# #18-NA-346: Vehicle Will Not Start and/or Service Electronic Steering Column Lock System Message Displayed on Driver Information Center (DIC) - (Nov 14, 2018)

**Subject: Vehicle Will Not Start and/or Service Electronic Steering Column Lock System Message Displayed on Driver Information Center (DIC)**

Brand:	Model:	Model Year:		Breakpoint:		Engine:	Transmission:
		from	to	from	to		
Chevrolet	Corvette	2005	2005				Equipped with 6 Speed Manual Transmission (RPO MM6)

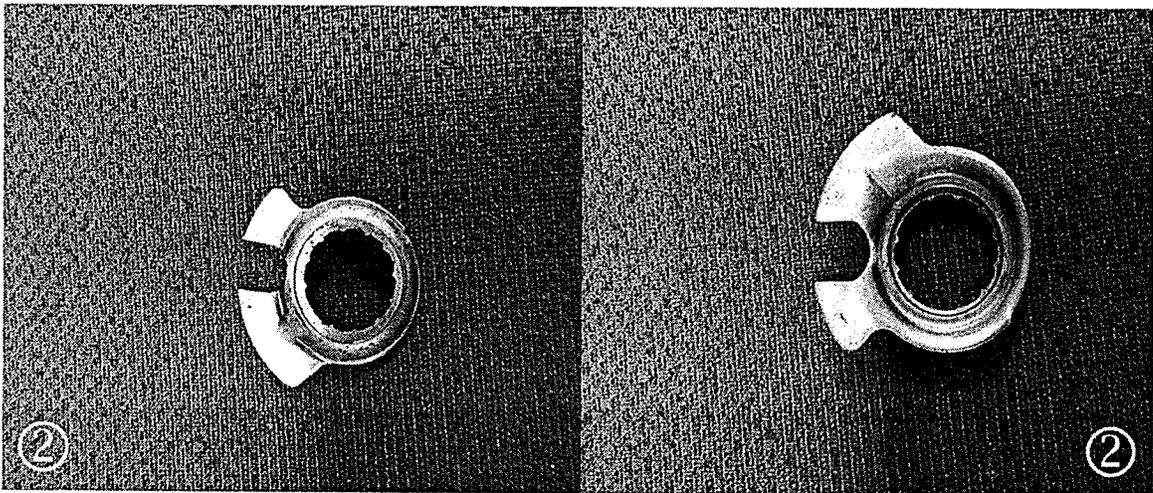
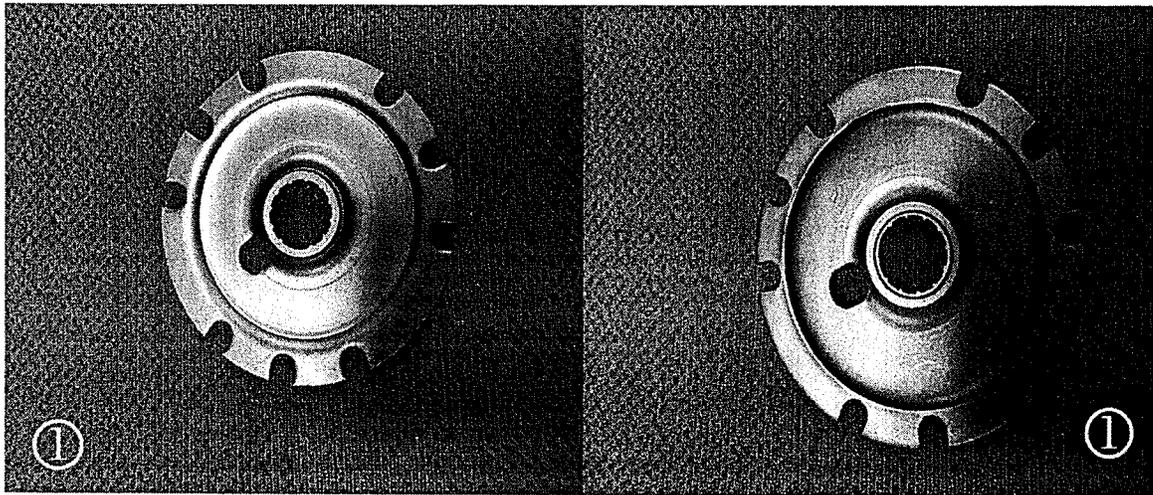
Replace the steering column lock plate (1) with the new plate (2), and update the BCM with the new utility file.

**Important:** MUST use J 23653-SIR and J 42137 when installing the cam orientation plate and retaining ring. Failure to use these tools may result in damage to the cam orientation plate, retaining ring and/or steering column components.

**Note:** DO NOT reuse the original retaining ring.

**Note:** The customer needs to be informed that the locking feature will no longer work after the new plate has been installed.
